Answers to Anonymous Referee #1 comments

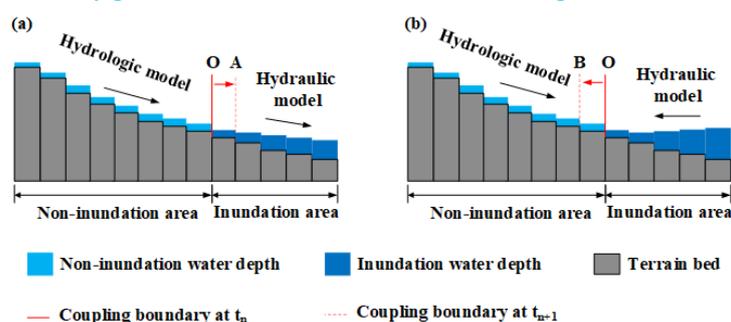
line 212, "is moved to point A", so where was it before?

This indicates the coupling boundary position at the present time step. For the first case, the coupling boundary position will moved to A in the next step, as shown in the following figure (a).

In the modified manuscript, the paragraph has been rewritten to make it clear. See line 198~204 in the modified manuscript.

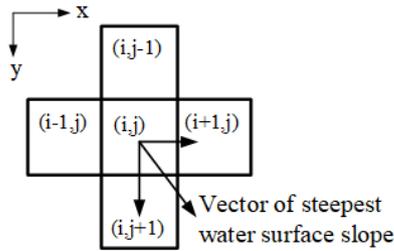
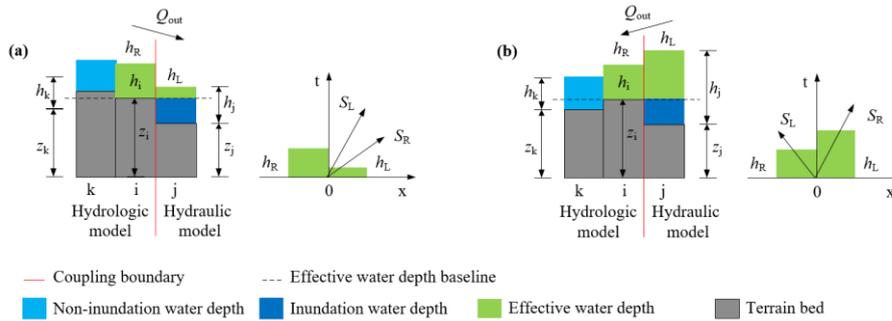
Figure 4, why water cannot flow to the left in the middle figure?

This is because the effects of gravity are that the flow at any point will trend to be in the direction of the steepest water surface slope (Bradbrook et al., 2004), as shown in the following figure:

For clarification, figure 4 (Figure 5 in the modified manuscript) was modified as following:
